No. 93-24

A. BRAVO THREE BEARING CARRIER OIL SEALS

BRAVO THREE DRIVES (ONLY)

73585

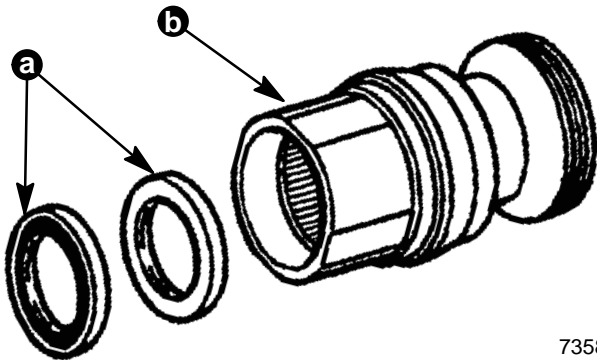
Bearing carrier oil seal, The rubber seal may be loose in the steel casing and could cause oil to leak from the outer propeller shaft area and also may allow water to leak into the drive unit, In either case this could cause damage to the drive unit, and they should be replaced.

(2) 26-805080 Oil Seals

(Shown in the illustration below)

a - Oil Seals (2)

b - Bearing Carrier

Follow the repair procedures in service manual Number (11) section (3D) Gear Housing Repair.
